Economic Development and Planning Committee

Proposed Zoning By-Law Amendment Brockville General Hospital Expansion 70, 75, 80, 94, 100, And 108 Charles Street, 94, 100, 118, 126, 134, 150, 152, 156 and 156a Bartholomew Street, and 150 And 156 Pearl Street East, City Of Brockville

REPORT TO ECONOMIC DEVELOPMENT PLANNING COMMITTEE - PUBLIC MEETING - July 7, 2015

2015-073-07
PROPOSED ZONING BY-LAW AMENDMENT
BROCKVILLE GENERAL HOSPITAL EXPANSION
70, 75, 80, 94, 100, AND 108 CHARLES STREET,
94, 100, 118, 126, 134, 150, 152, 156 AND 156A
BARTHOLOMEW STREET, AND 150 AND 156
PEARL STREET EAST, CITY OF BROCKVILLE
OWNERS: BROCKVILLE GENERAL HOSPITAL,
DOUG AND DEBBIE BROOKS, CANADIAN
RED CROSS SOCIETY
APPLICANT: FOTENN CONSULTANTS INC.
FILE NO.: D14-008(050-2014)

APPENDIX A — CONCEPTUAL SITE PLAN

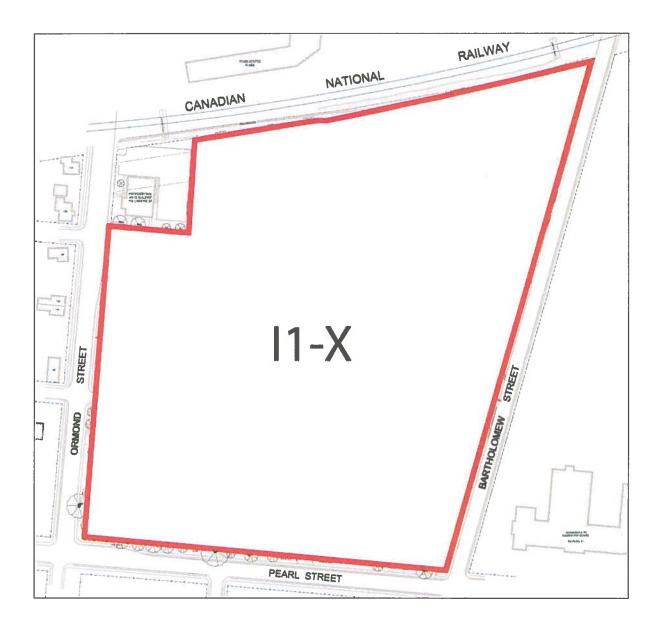
- 1. The Transportation Planning Study projects a demand for 760 parking spaces for staff and visitors. The current version of the site plan shows 739 parking spaces. It is recommended that 760 parking spaces be provided to minimize the impact of on-street parking in the surrounding residential area.

- 3. It is unclear from the current version of the site plan whether Charles Street is intended to remain as a public street, or become an internal roadway for the hospital site. Based on the current configuration, the Operations Department prefers that the Charles Street road allowance be transferred to the hospital in order to avoid maintenance concerns, particularly with respect to winter maintenance.
